ADDENDUM #1 – JUNE 13, 2025

RE: COOS BAY SCHOOL DISTRICT
Restroom Remodels
Project #24.072 & 24.079

FROM: HGE ARCHITECTS, Inc.
333 South 4th Street
Coos Bay, Oregon 97420
541-269-1166

3. **Bid Schedule A - Sheet A2.1, Main Building – Restroom Plan:** Make the following changes:
 - a. CHANGE red "SIZE" note to "5-1/2" x 7-1/2" GLB"

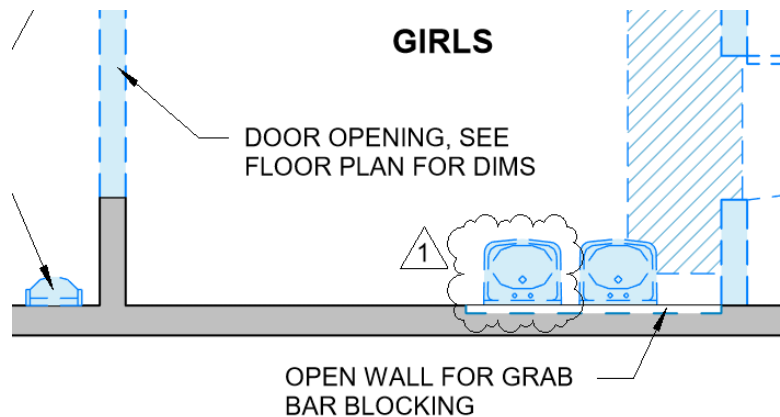
- b. REVISE drawing per the following:
- ADD note "ACCENT FLOORING COLOR"
 - ADD floor accent pattern as shown below:
